### PLANNING COMMISSION REGULAR DOCKET TUESDAY, December 8, 2015 – 5:30 P.M. CITY COUNCIL CHAMBERS

- H. Site Plan**
  - a. Market Plaza

**CITY OF CHARLOTTESVILLE**  
**DEPARTMENT OF NEIGHBORHOOD DEVELOPMENT SERVICES**  
**STAFF REPORT**

# Attachment I

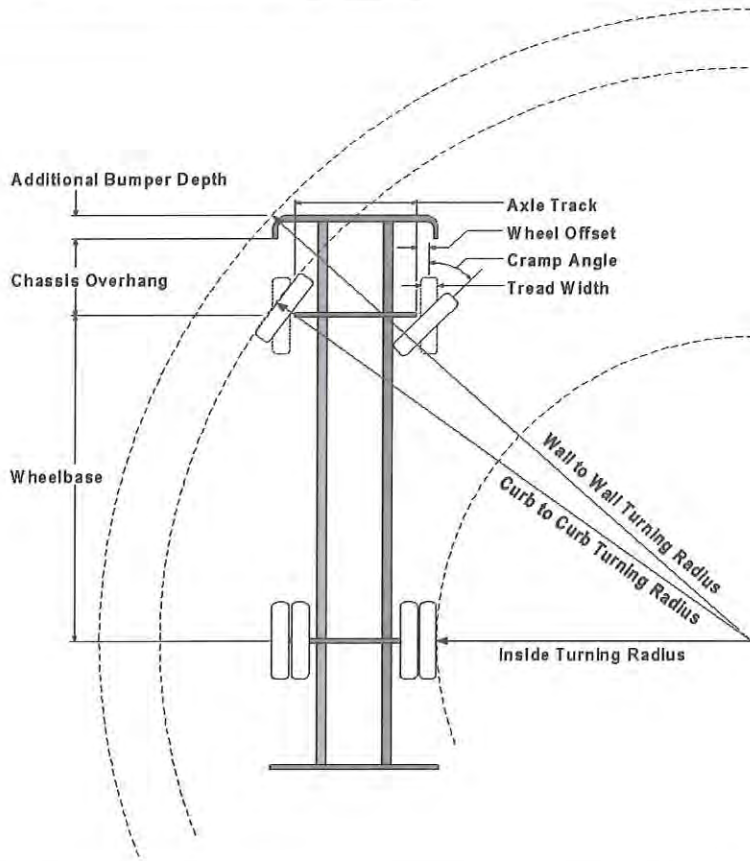
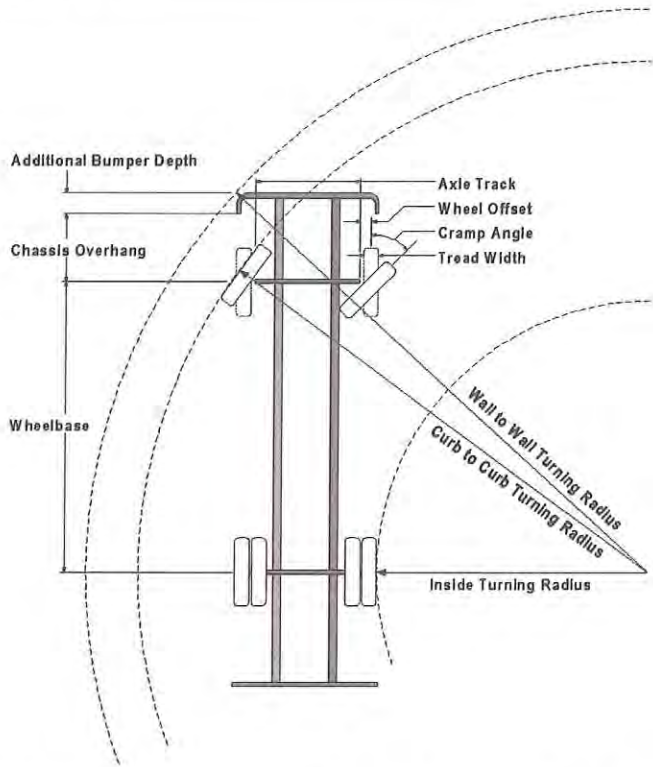
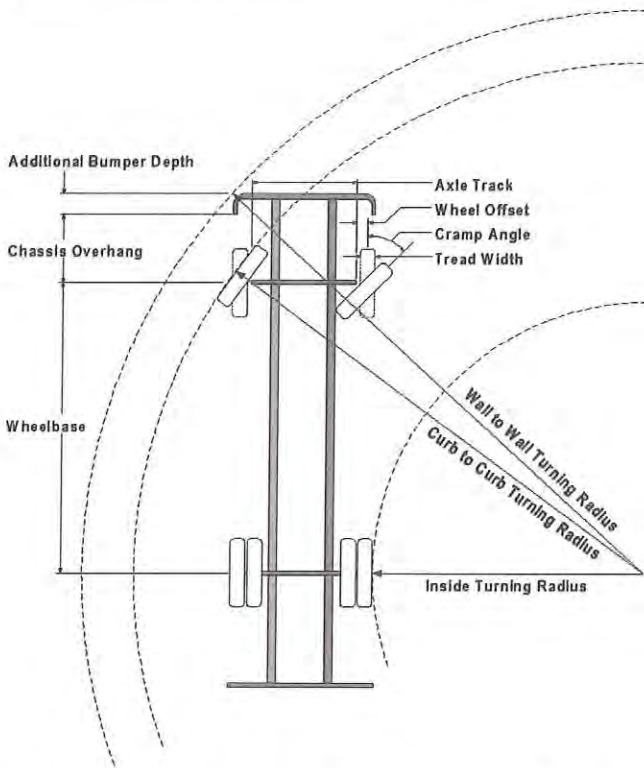
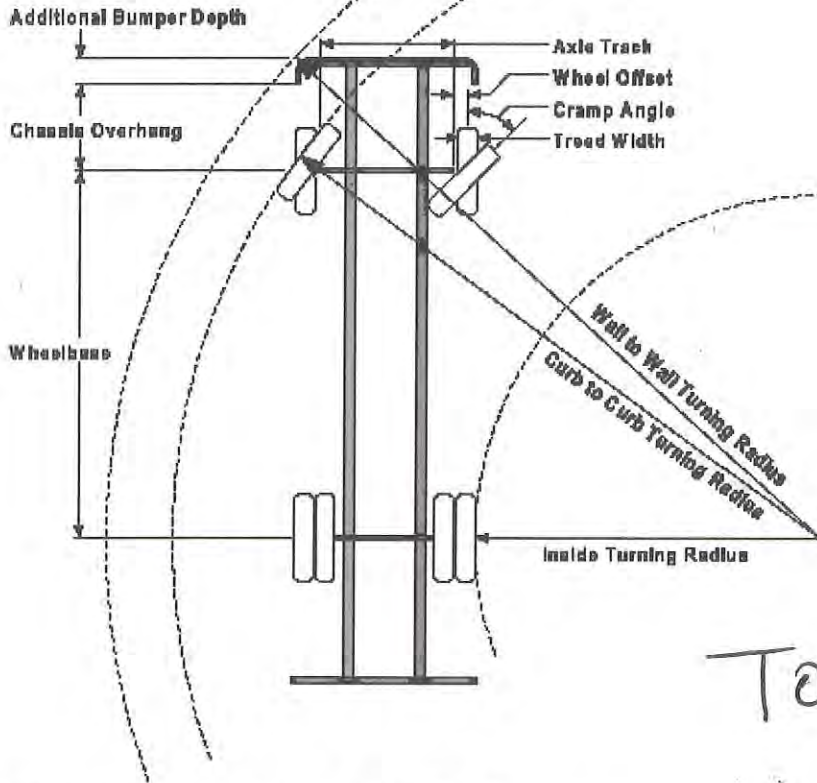
**1. Will the new fire trucks, both the one we just purchased and the one we plan to purchase, require a 20-foot clearance?**

Turning radius and the width of streets are two different measures, though both are related to the size of our fire equipment. *Attachment I* is a drawing of the performance of the 2 new engines that should arrive later this month as compared to the last one purchased a couple of years ago. As you can see from the attachment the newer models have a smaller turning radius.

Landscape Site Plan

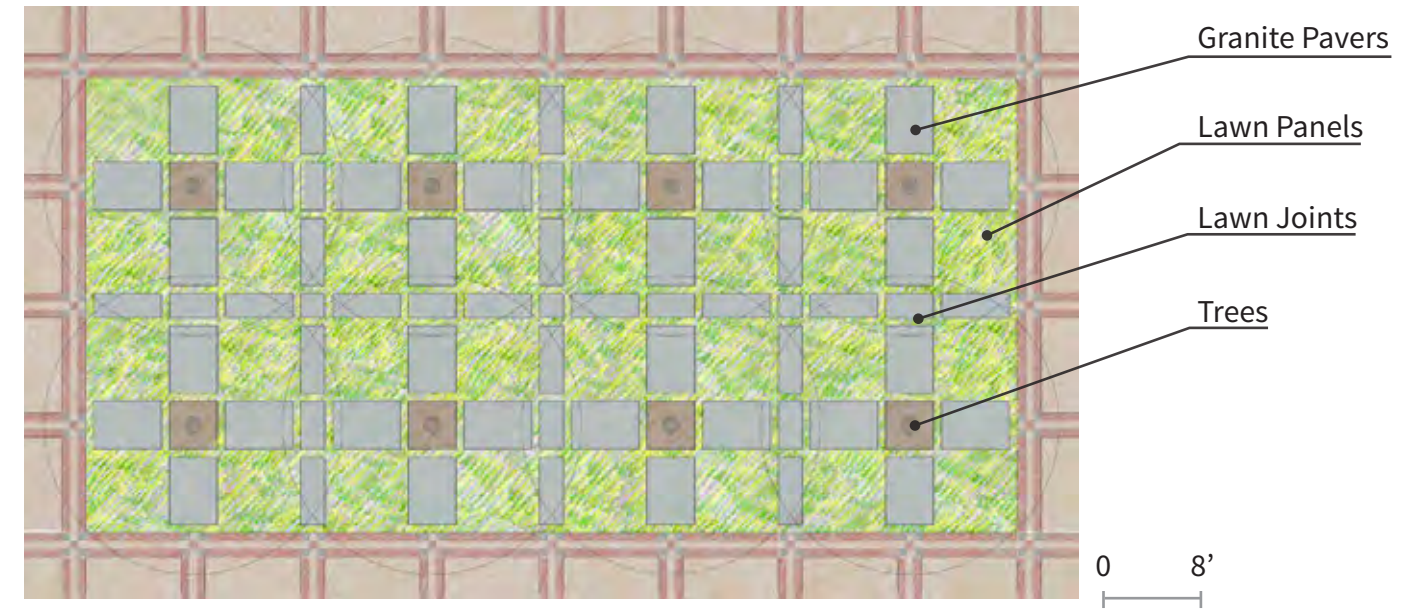
39. Please show detailed grading for the driveway entrances on the final site plan.
40. The short term bike parking as shown on L1.01 will not be usable (assuming standard U staple racks). Bike racks need to be placed 24” from a wall and, if oriented as shown, provide at least 8’ between racks. Also, racks placed in the public sidewalk need to provide adequate pedestrian clearance (6’ min.) If this cannot be achieved in the proposed location, consider alternate locations that provide the same level of accessibility to the Plaza.
